PLES I GEOTHERMAL DEVELOPMENT PROJECT

FINAL ENVIRONMENTAL IMPACT STATEMENT AND SUPPLEMENTAL ENVIRONMENTAL IMPACT REPORT

June 1989

FIGURE 2-1
Proposed Project Site Plan

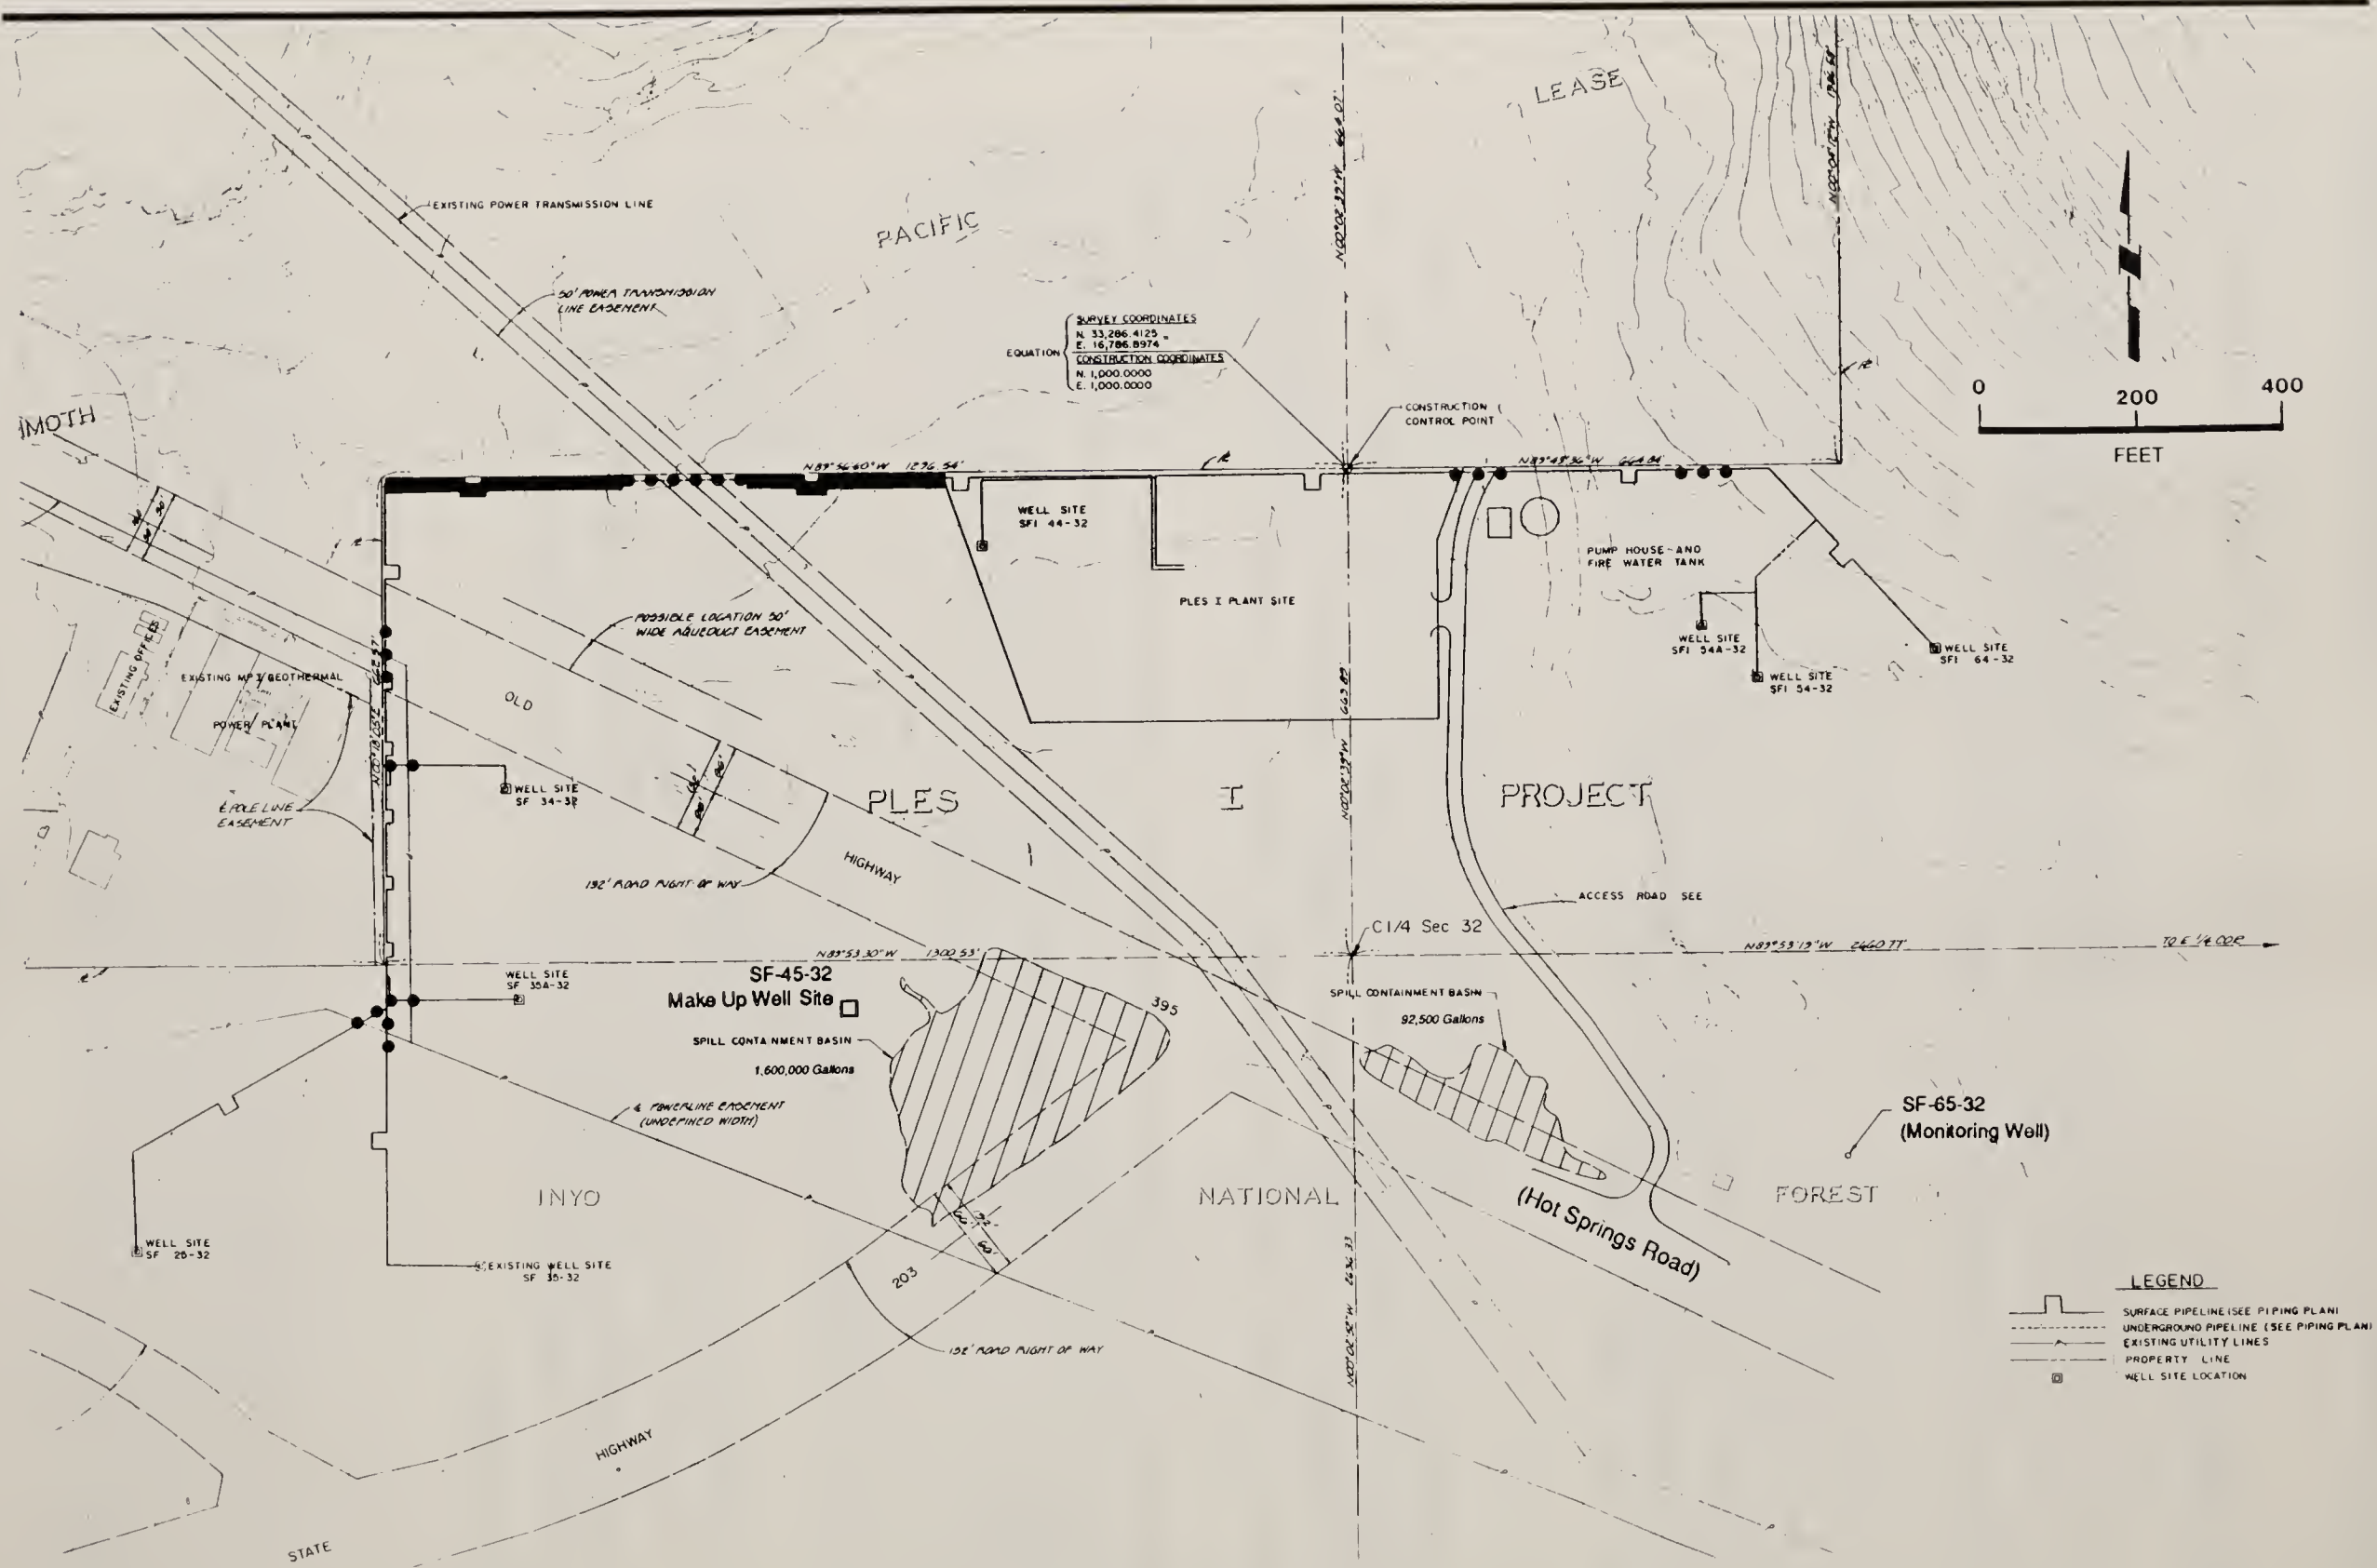
6-8 Page 2-15, "Gathering System" describes the layout and construction techniques used in pipeline layout. Nowhere in this description does it say that there will be "underground piping". This is in conflict with Figure 2-1 which indicates that segments of the pipeline will be "underground piping", as compared to being "below grade" in an open trench. The difference between these two will have significant detrimental or beneficial effects on migratory mule deer. This is also true of the description of the injection system described on page 2-21.

Response: Pipeline configurations for the proposed project are shown on Figure 2-1. Not only does this figure show pipeline routing, it shows areas where pipelines would be trenched or buried. Appropriate text has been edited to make entirely clear that Figure 2-1 is accurate.

FIGURE 2-6
Alternate Power Plant Location

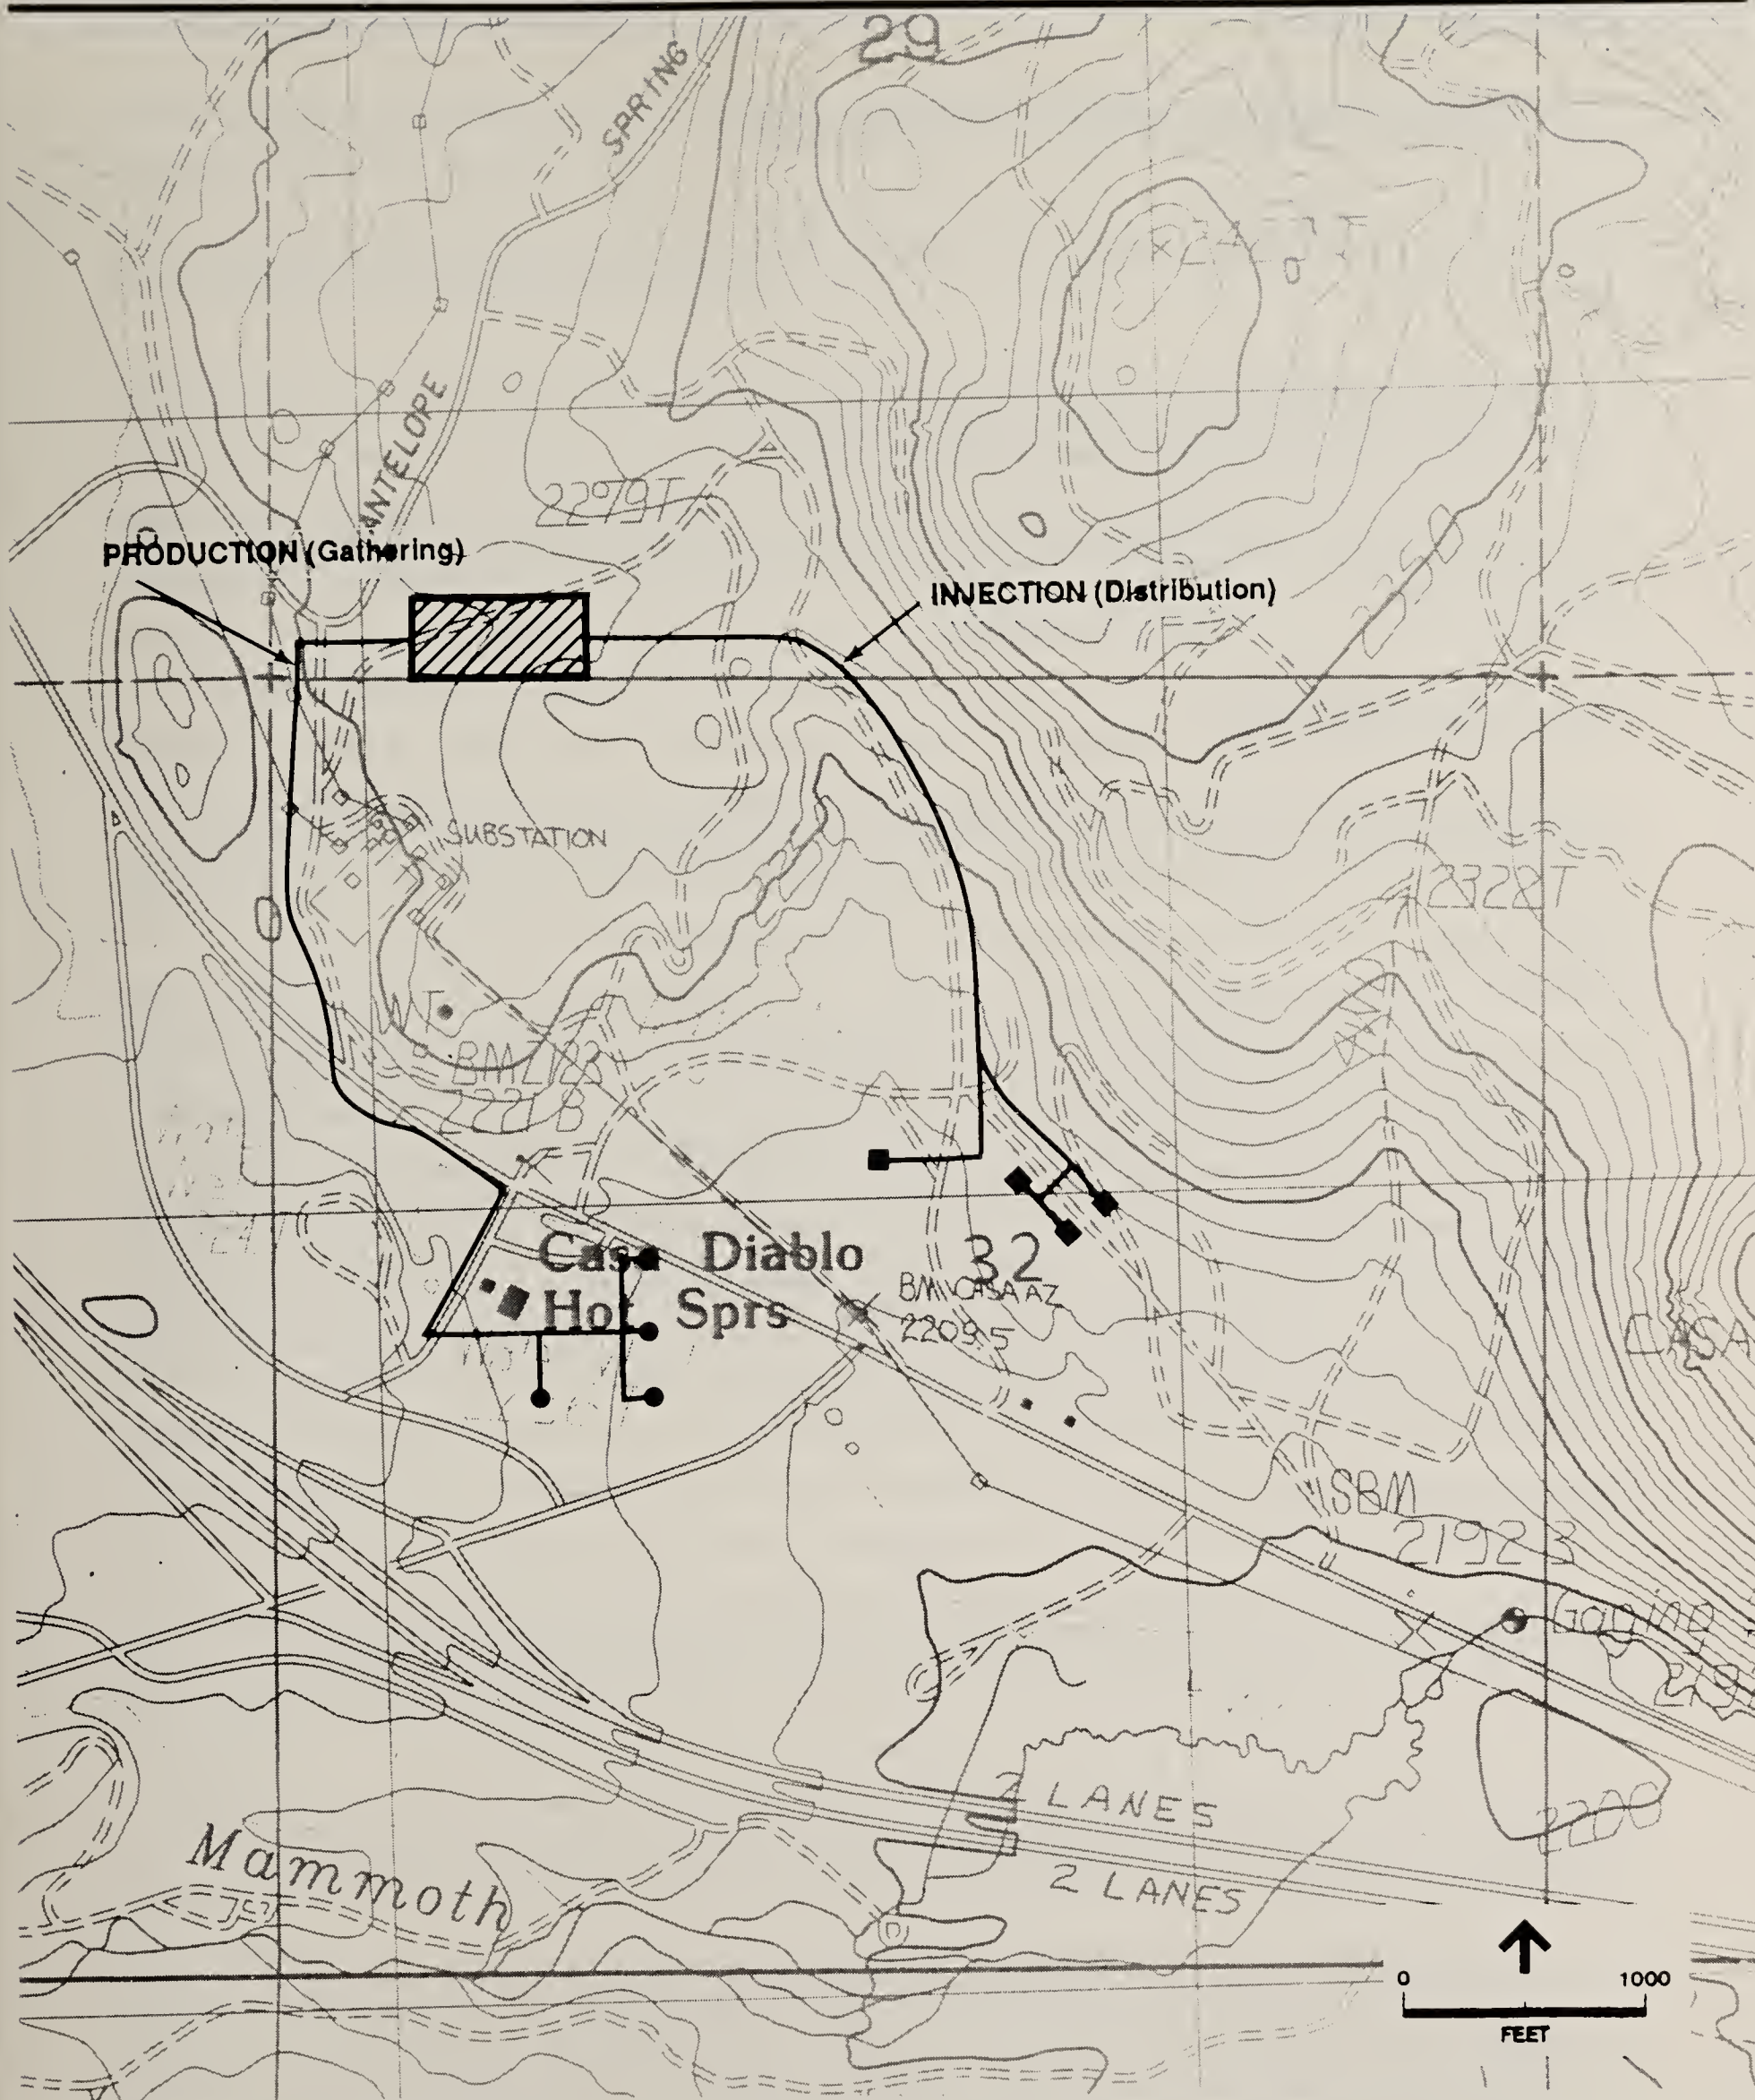
6-12 Figure 2-6 illustrates this underdeveloped alternative concept quite well when compared to Figure 2-1 ("preferred alternative"). Compare the level of detail that each of these figures provides. Which portions of the pipeline in figure 2-6 are to be placed in "excavated trenches"? Where is section 2.1.7.9 that supposedly describes this pipeline construction detail?

6-13 It is unclear from examining figure 2-6 exactly which of the sections of fluid transmission lines for this alternative will be buried or subgraded to mitigate impacts on migratory mule deer. How can permitting agencies evaluate such potential impacts lacking such information?

For instance, Figure 2-6 gives no indication of where or if these techniques will be used for the Alternative Site Facility Location. The mitigation listed for this impact under the Alternative Location impacts is to locate the power plant in the "preferred" location. This is a prime example of how the DEIS handles its treatment of alternatives throughout. In this case, the mitigation should focus on the resource as affected by the alternative in question, not simply refer back to the preferred location to solve the problem. This type of treatment of alternatives is another serious deficiency of the DEIS.
